PLANNING COMMITTEE – 19 October 2023

23/0698/FUL - Demolition of existing conservatory, construction of single storey front extension and part single, part two storey side and rear extension, basement and front porch extension, loft extension including increase in ridge height, change of hipped roof to gable above front entrance, rear dormers, side rooflights, internal alterations and alterations to fenestration, landscaping alterations to the rear at 9 RUSSELL ROAD, MOOR PARK, NORTHWOOD, HERTFORDSHIRE, HA6 2LJ.

Recommendation: That Planning Permission be granted.

Appendix 1

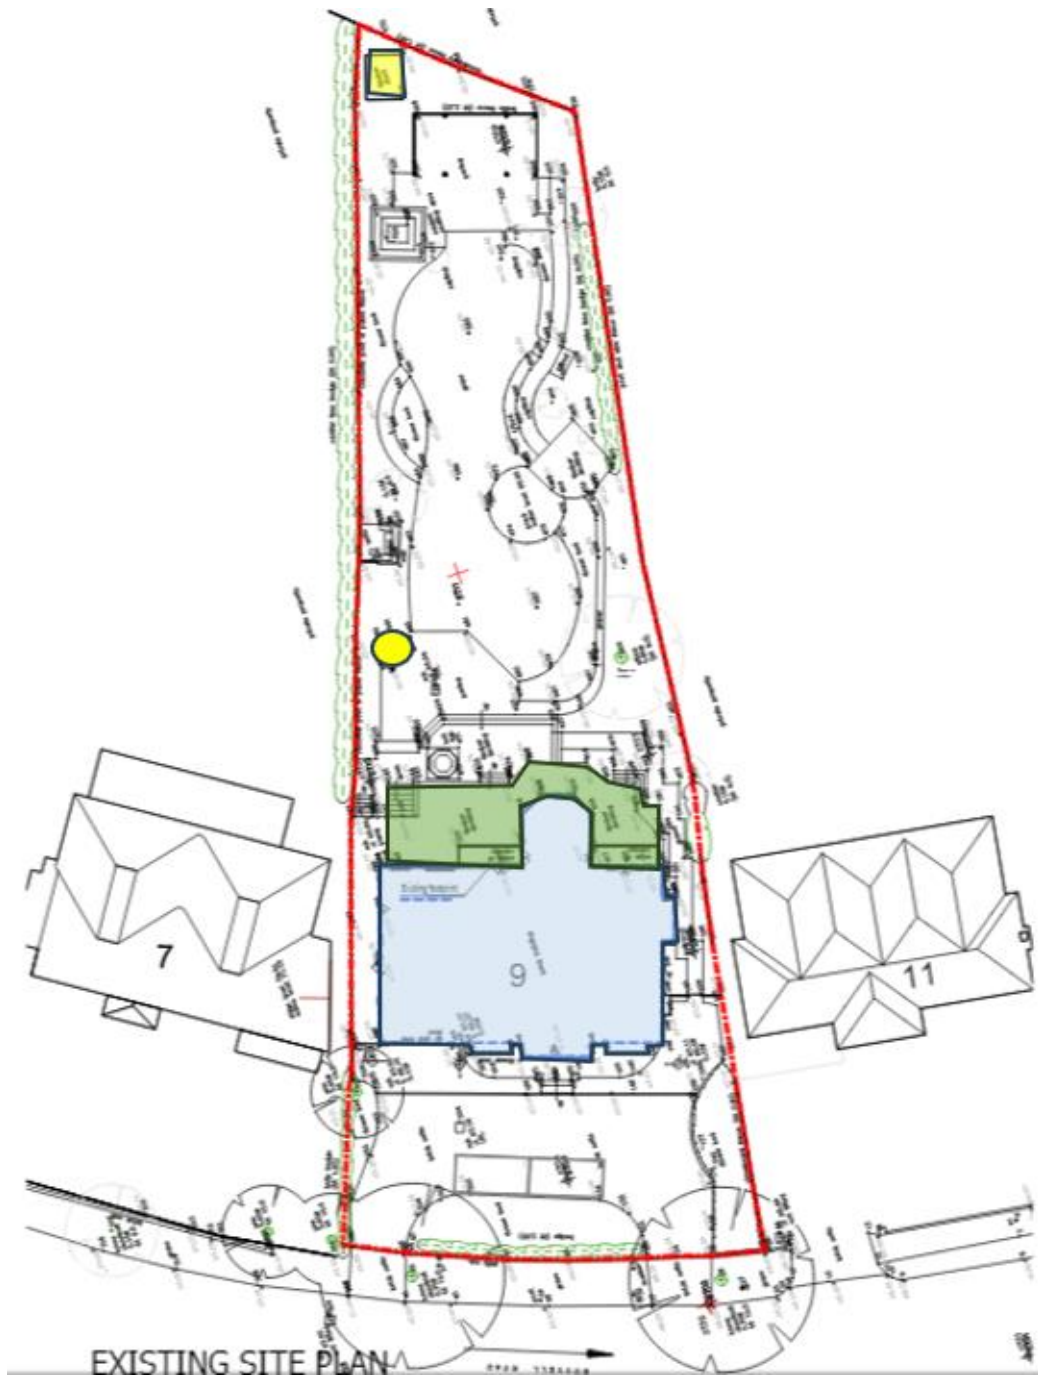
- 7.1.20 From the submitted plans the existing plot coverage of the existing house is 15% and this increases to **20%** when taking into account the existing basement and raised decking above. When including the existing outbuildings, the total plot coverage of the house as existing (including basement and most elevated raised timber decking area above the basement) equates to **21%** (see **Appendix 1**).
